APPLICATION NO.	FILING DATE	FIRST NAMED INVENTOR	ATTORNEY DOCKET NO.	CONFIRMATION NO.
10/574,401	04/03/2006	Josef Artelsmair	ARTELSMAIR-6PCT	5900

Office Action Summary	Application No.	Applicant(s)	
	10/574,401	ARTELSMAIR, JOSEF	
	Examiner	Art Unit	
	HUNG NGUYEN	3742

DETAILED ACTION

FIG. 4

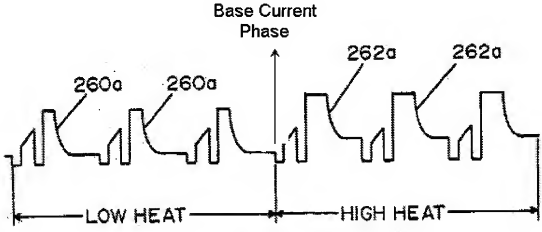
31. Regarding claim 32 and 34, Jank/Hsu disclose substantially all features of the claimed invention as set forth above including from Hsu, the high energy input phase is a high current phase, the base energy phase is a base current phase (Col. 1, Line 66 to Col. 2, Line 1; Col. 5, Line 51 to Col. 6, Line 17) (Fig. 4 below shows the sample cycle between the low heat follow by a high heat during the base current) **except** a ratio of the number of pulses of the first welding process phase to the number of pulses of the second welding process phase is adjusted to adjust or control the heat balance or heat input into the workpiece. Ueyama et al. discloses a ratio of the number of pulses of the first welding process phase (Fig. 97 shown 3 pulses for T1) to the number of pulses of the second welding process phase (Fig. 97 shown 4 pulses for T2) is adjusted to adjust or control the heat balance or heat input into the workpiece (Fig. 96 clearly shown the

number of pulses is adjust between the two phases T1 and T2) (Col. 71, Lines 5 to Col. 72 Lines 10). It would have been obvious to one of ordinary skill in the art at the time of the invention was made to utilize in Jank/Hsu, a ratio of the number of pulses of the first welding process phase to the number of pulses of the second welding process phase is adjusted to adjust or control the heat balance or heat input into the workpiece, as taught by Ueyama et al., for the purpose of controlling the arc length between the first and second phase.
